**Project: IEEE P802.15 Working Group for Wireless Personal Area Networks (WPANs)**

**Submission Title:** [MSC figures in draft and updated figures status]

**Abstract:** [MSC figures in draft and updated figures status]

# MSC in D1 draft

### Message sequence chart for color frame configuration

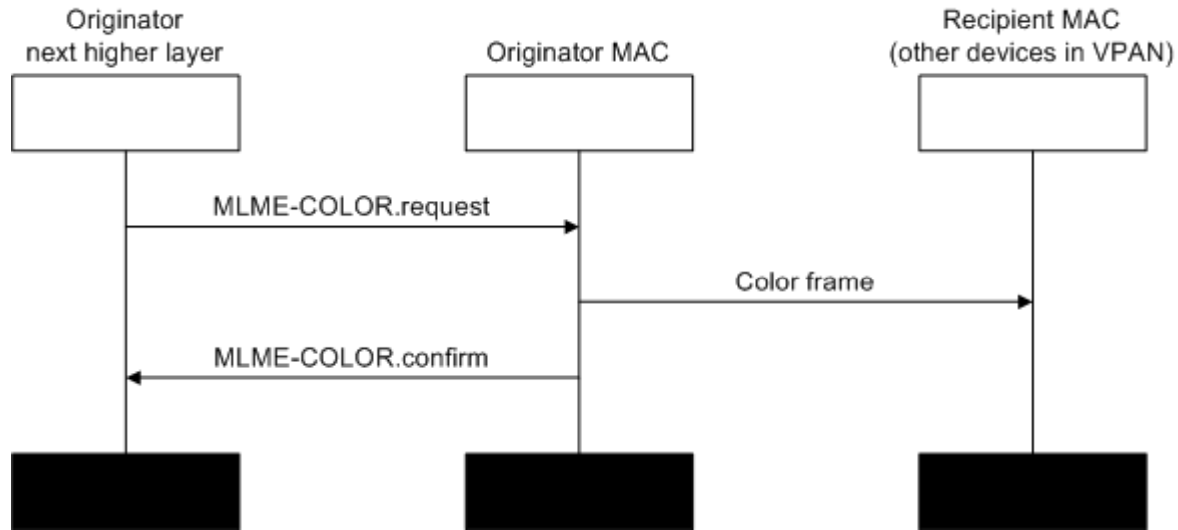
❖ New figure for color frame configuration
